FIELD SERVICE CAMPAIGN – 16138

Fan Hub Mounting Bolts

DuraStar®, WorkStar®

Figure 1. Fan Drive

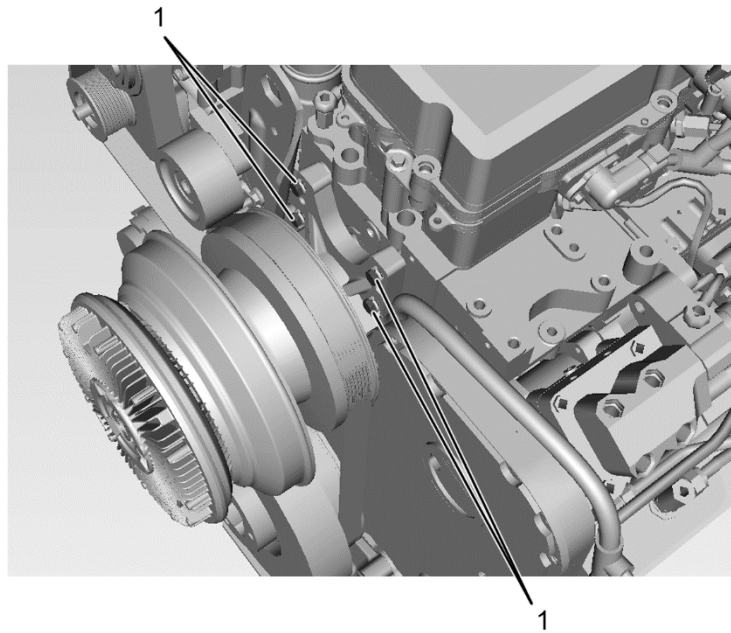
The fan hub mounting bracket may be loose on certain DuraStar® and WorkStar® vehicles with Cummins® ISL engines due to the mounting bolts being too long.

1. Fan drive mounting bolt (4)
5. Remove one fan drive mounting bolt (Figure 1, Item 1). Discard bolt and washer, if equipped.
6. Install new 35mm long fan drive bolt with no washer. Using a torque wrench, torque to 50 lb-ft (68 N•m).
7. Repeat Steps 5 and 6 on remaining three fan drive mounting bolts.
8. Verify torque on all four fan drive mounting bolts.
9. Close and latch hood.
10. Remove wheel chocks.
